Save the Wild U.P. Written Comments to DEQ

Aquila Resources Back Forty Mining Permit Application and EIA Project ID: 14A021

Submitted February 16, 2016

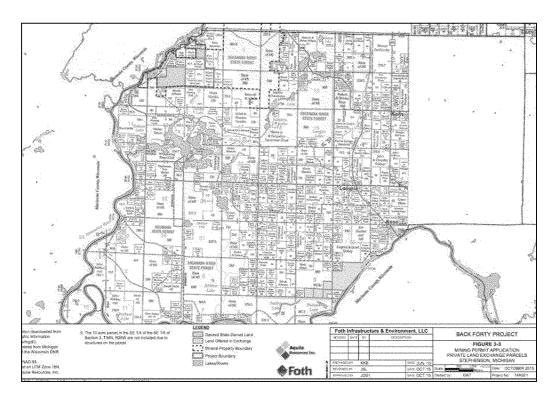
- The Land Ownership described in mine permit application is misleading (see MPA Volume I, and figure 3-3, included below, land "proposed for land exchange" and "Land Offered for Exchange"). The acreage designated as being owned or controlled by Aquila and offered to the State of Michigan in the Land Swap is not actually owned by Aquila. According to a 2012 plat book, the last owner was Wells Fargo. Wells Fargo sold the land to Northern Michigan Land Brokers, which may be acting as a holding company or may have signed a "purchase agreement" with Aquila. The bottom line is that Aquila Resources does not currently own the property they are proposing to swap with the State of Michigan, and MDNR staff are aware of this.²
